Access Compliance Report Public Rights-of-Way (Curb Ramps)

Intersection ID: 15882Main Street: EAST_BVCross Street: QUEENS_RD_WESTLocation:NEADA ID: DCBD3F4A2CD0Ramp Type: PerpInitial Pass/Fail: FailOverall Compliance: NoSeverity Score: 13.75

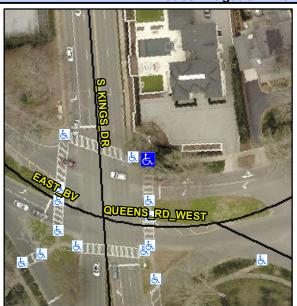
ossible Solution	
Possible Solutions:	Compl
Remove & Replace Entire Ramp.	N/A
•	Yes
	N/A
	N/A
	N/A
	N/A
Surveyor Notes:	N/A
N/A	N/A
	N/A
	N/A
	N/A
PROW/ADA:	N/A
R304.2.2, R304.5.3	N/A
	N/A
	N/A
	N/A

Comp	liance Description	Data	Comp	liance Description	Data
N/A	Ramp Length (in)	50.0	No	Ramp Slope (%)	9.2
Yes	Ramp Width (in)	48.0	No	Ramp XSlope (%)	2.6
N/A	Flare Type LT	N/A	N/A	Flare Type RT	N/A
N/A	Flare Slope LT (%)	N/A	N/A	Flare Slope RT (%)	N/A
N/A	Flare Traversable LT?	N/A	N/A	Flare Traversable RT?	N/A
N/A	Landing Length (in)	N/A	N/A	DWS Provided?	N/A
N/A	Landing Width (in)	N/A	N/A	DWS Contrast?	N/A
N/A	Landing Slope (%)	N/A	N/A	DWS Length (in)	N/A
N/A	Landing X Slope (%)	N/A	N/A	DWS Full Width?	N/A
N/A	Landing Curb? (Y/N)	N/A	N/A	DWS Offset (in)	N/A
N/A	Shared Landing?	N/A			
N/A	Gutter Ponding?	N/A	N/A	Gutter Slope (%)	N/A
N/A	Gutter Lip Ht (in)	N/A	N/A	Gutter X Slope (%)	N/A
N/A	Painted X Walk1?	Yes	N/A	Painted X Walk2?	N/A
	X Walk 1 Direction	To S		X Walk 2 Direction	N/A
N/A	X Walk 1 Width (in)	112.0	N/A	X Walk 2 Width (in)	N/A
	X Walk 1 Slope (%)	4.3		X Walk 2 Slope (%)	N/A
	X Walk 1 X Slope (%)	0.9		X Walk 2 X Slope (%)	N/A
